HISTORIC AND DESIGN REVIEW COMMISSION

HDRC CASE NO: 2015-245
COMMON NAME: 114 CEDAR, 139 CEDAR, 233 CEDAR, 311 PEREIDA
ADDRESS: 133 CEDAR ST
LEGAL DESCRIPTION: NCB 935 BLK B LOT 7 & 8 & N 12.4 FT OF 9
ZONING: MF33-S H
CITY COUNCIL DIST.: 1
DISTRICT: King William Historic District
APPLICANT: Jim Bailey/Alamo Architects
OWNER: Stephen Yndo/Children's Shelter of San Antonio
TYPE OF WORK: New construction, relocation of historic building
REQUEST:

The applicant is requesting conceptual approval to:

SITE PLAN

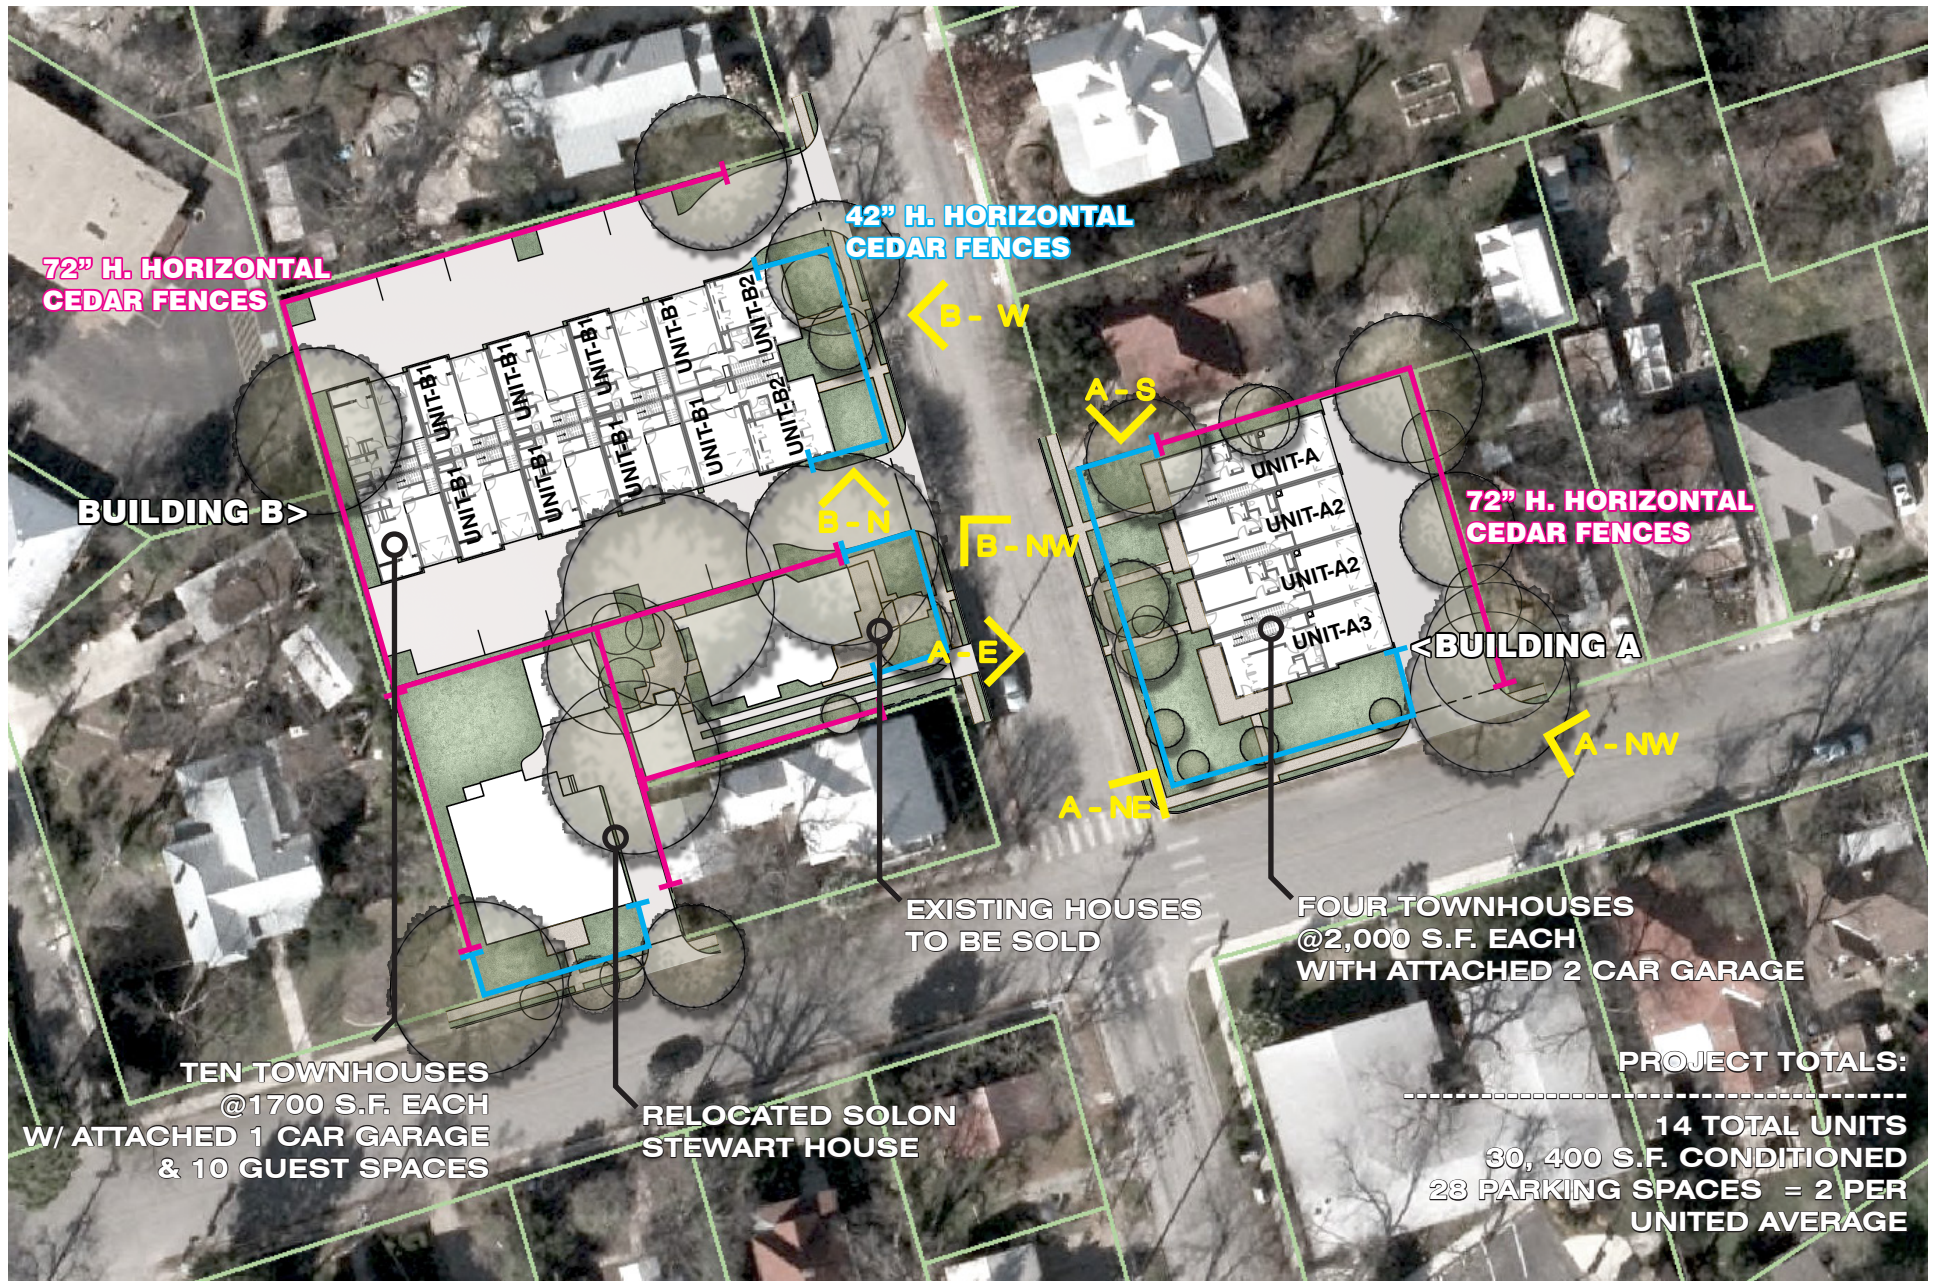
- m. The applicant has provided a site plan noting existing trees on the property. The applicant is responsible for complying with the Historic Design Guidelines for Site Elements 3.D. as well as the UDC Section 35-525 in regards to tree preservation. Species selection and planting procedure should be done with guidance from the City Arborist.

- i. That the applicant provide information regarding the location of mechanical equipment prior to returning for final approval.
- ii. That the applicant provide a detailed site plan prior to returning for final approval.
